Resilient communities, land restoration and sustainable ecosystem management

Review CEO Endorsement and Make a recommendation

11212

FAO

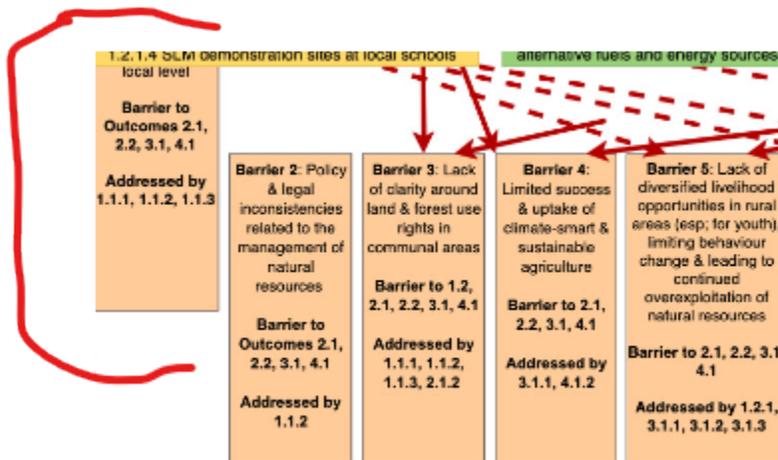
ii) Barrier 1 Box needs to be shifted to the level of others so as to be legible but pathways now clear. Once moved, comment is cleared. see below screenshot for reference:

b) ii) This has been amended and the revised figure added.

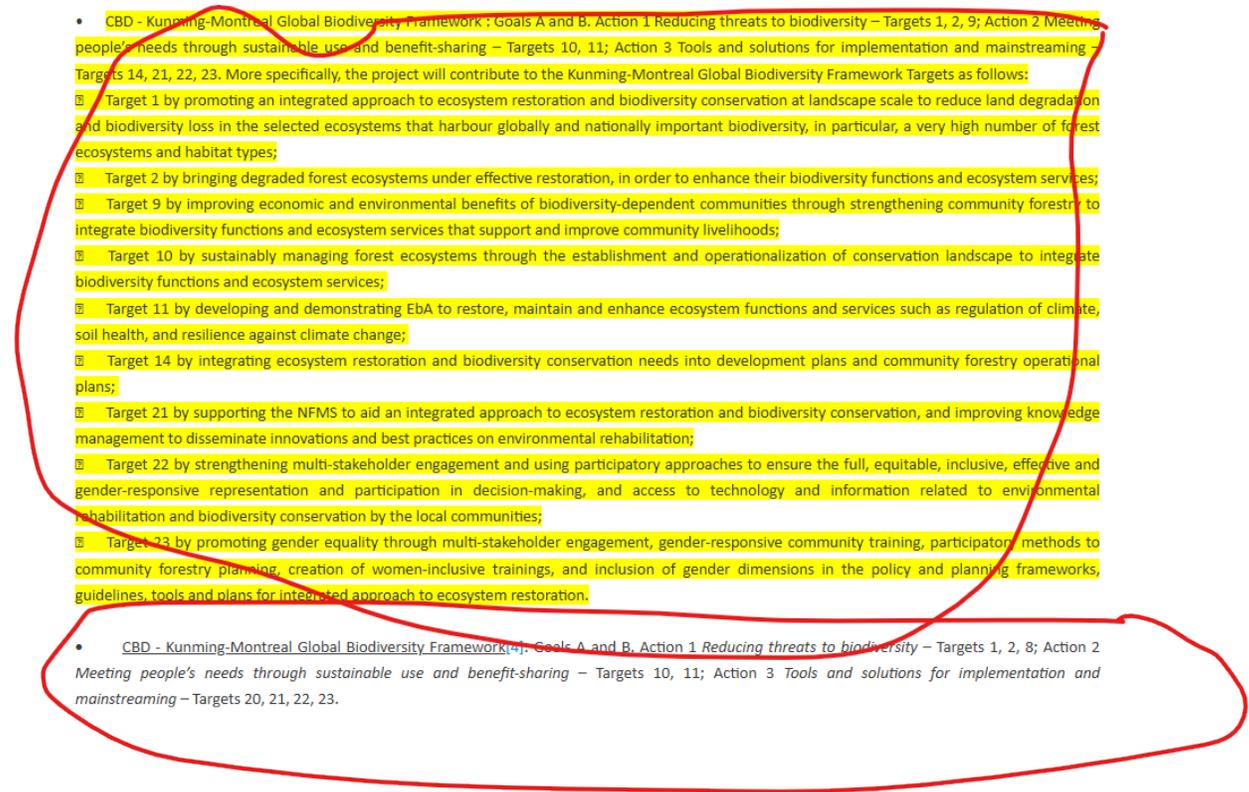
a) Section C was ammended and relevant information added . However, there are now two elaborations in the portal entry that are not consistent with one another (see below screenshot): Please consolidate the two elaborations above and focus on targets on which the project had the main contributions, which seem to be targets 1, 2, 8, 10, 11, 20, 21, 22, 23.
